IN THE DRAWINGS:

KLAUS ZUCHOLL et al. U.S. Appl. S.N. 10/849,030

Marked Up Copy U.S. Appl. S.N. 10/849,030

Fig. 3

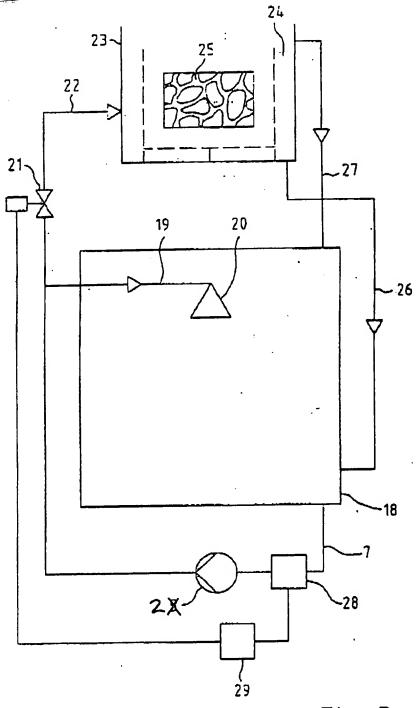
- 1. The duplicate copy of Fig. 1 (not labeled as Fig. 1) has been deleted.
- 2. In Fig. 3 the reference character "5" has been corrected to reference character "2" to indicate a pump as correctly assumed by the Examiner and as indicated in red in the appended "marked up" copy.
- 3. The European format "1/3", "2/3" and "3/3" have been corrected by their removal from the replacement sheets.

The Office Action correctly notes the informalities with the drawings including the unnumbered duplicate of FIG. 1, the problem of reference character "5" in FIG. 3 and the marking of the drawings "1/3", "2/3" and "3/3".

These informalities arose due mainly to the difference between U.S. and foreign patent practice. Nevertheless the error in FIG. 3 has been corrected to reference character "2" and the duplicative of FIG. 1 and the "1/3", "2/3" and "3/3" have been removed in the appended replacement drawings.
